X01 Planning variation ref. How the proposal differs from approval refs. 136318/LO/2023 and 139183/FO/2024

St Margarets (App. 2),  
Manchester  
For Charlotte Street Estates

### 1st Floor Plan Proposed

PROJECT REF. 2093  
DRWG NO. P(120)  
REVISION  
SCALE 1:100 @ A3  
DATE 1st Aug 25  
DRAWN GS

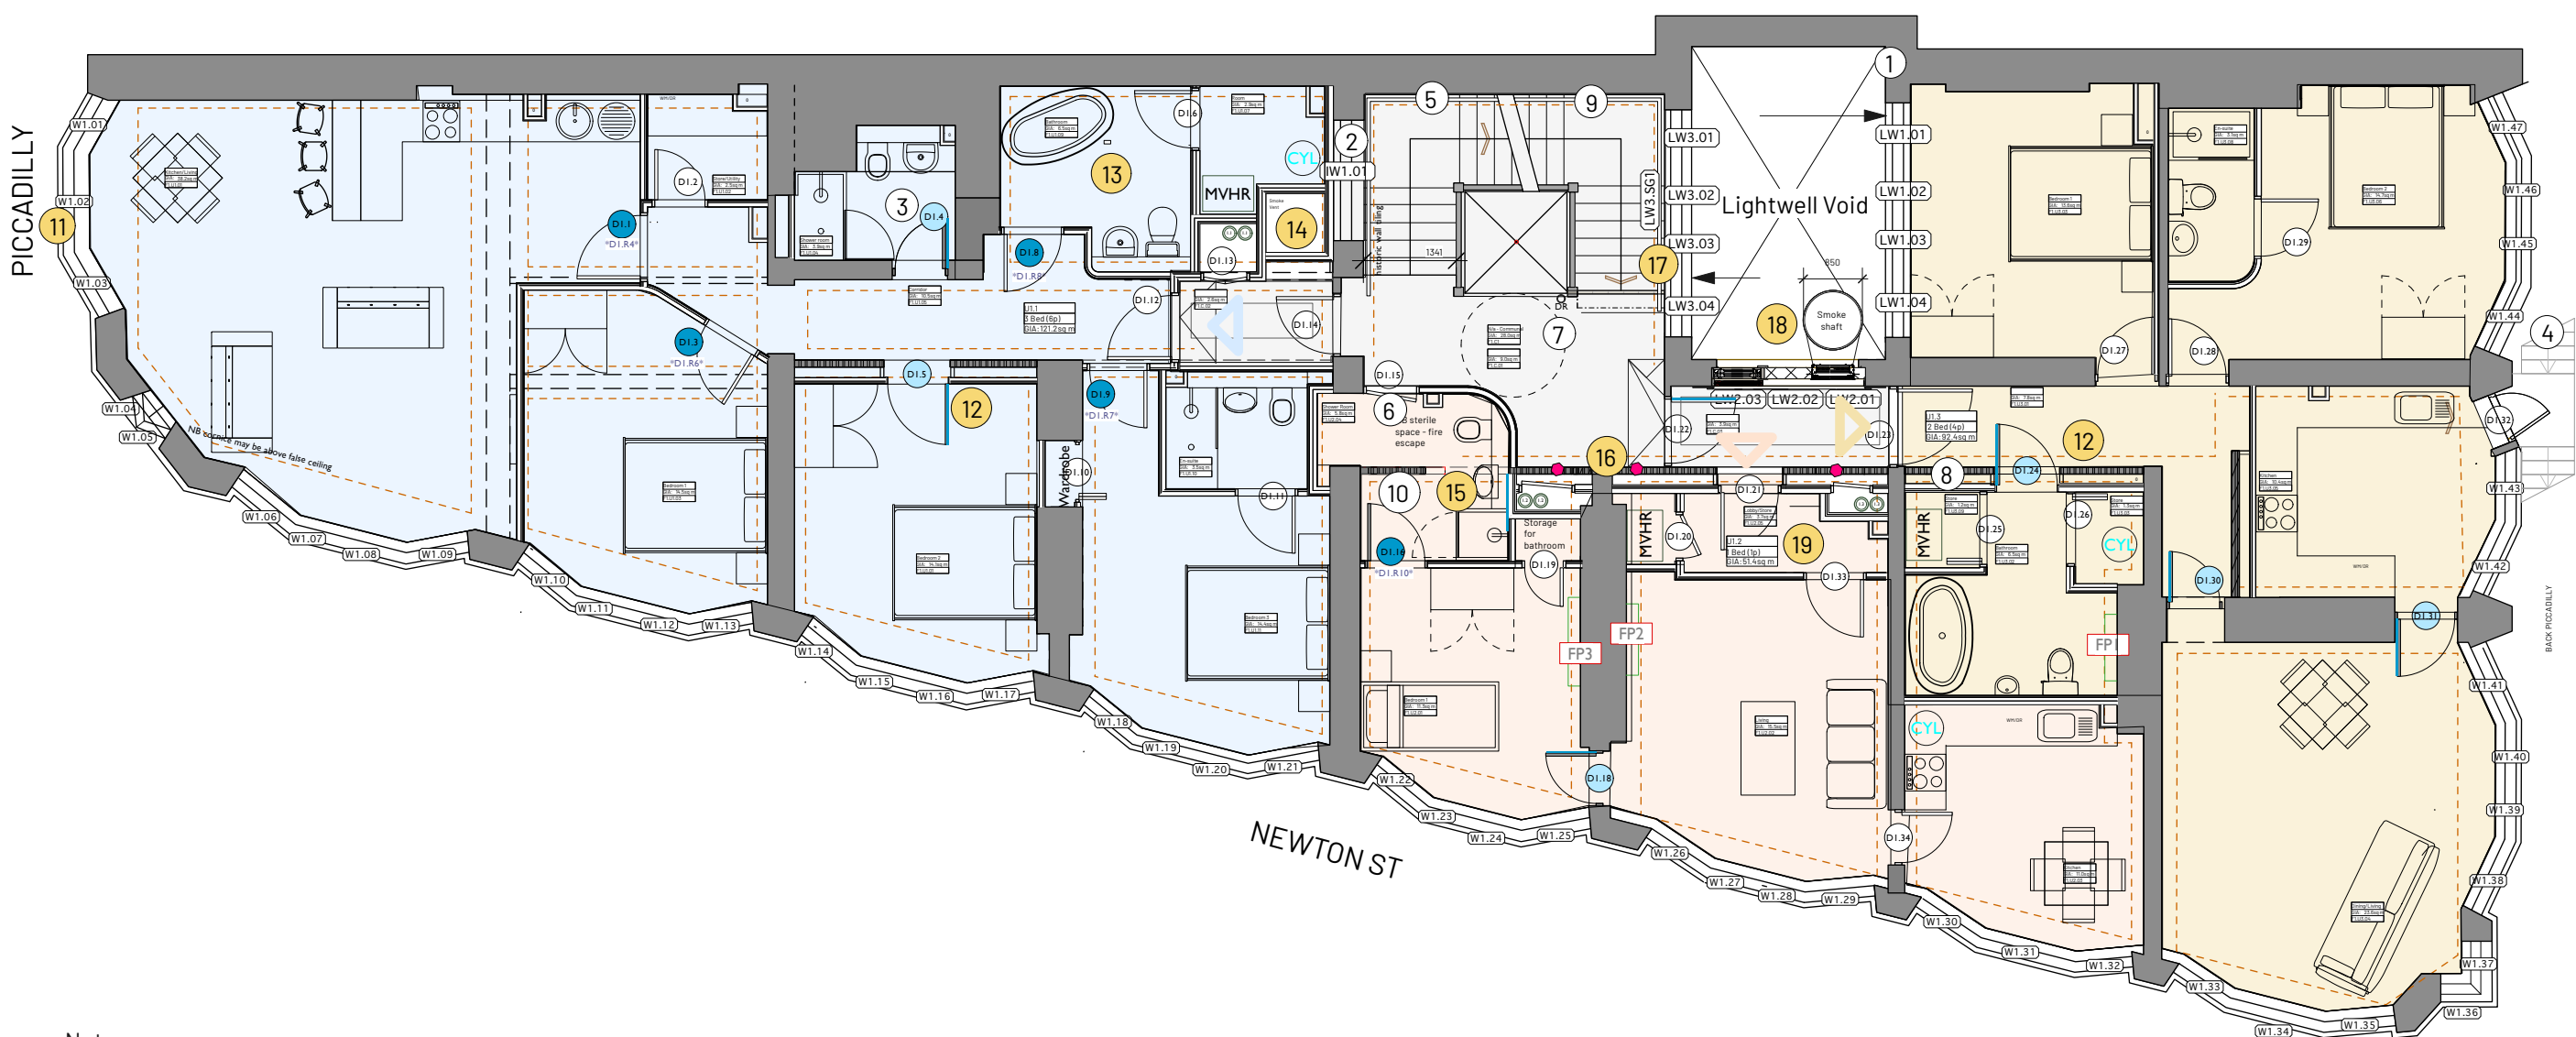
- Maintenance access to rooflight and gutter via temporary scaffold as required.
- New fire rated partition inserted within window reveal behind glass. LED lighting within void to be accessed via hatch within partition.
- NB: lift shaft internal faces shown indicatively.
- Existing fire escape stair. Retained and redecorated, but unused.
- Any unoriginal paintwork unsympathetically applied to historic glazed tiles in stairwell to be carefully removed.
- Concealed fire door to only be used in the event of an emergency.
- Dry riser.
- Exact placement of partition as per P(403).
- Proposed handrail.
- High level timber panelling retained - over shower room enclosure.
- Retention of steel windows with secondary glazing - due to opening up revealing these

likely to be original and depth insufficient to put new sash timber in. Repeated for all bays.

- Existing doors retained, but upgraded to achieve fire separation requirements, and relocated into fire rated partition. 102
- Unit 1.1. Bathroom relocated and store created to suit M&E requirements. 103
- Smoke ventilation riser added. Connecting louvred grille to be installed into existing panelled partition wall at this location. 104
- Bathroom design revised following client comments. Preference for full bathroom off bedroom rather than separate WC at entrance. 105
- Revised acoustic/fire separation wall details and duct interfaces - panelled walls. 106
- Lightwell secondary glazing - required to provide appropriate fire separation as per the fire strategy. 107
- Smoke shaft added, connected to louvre within corridor wall. As required following fire strategy development. 108
- Unit 1.2 entrance reconfigured without WC. 109
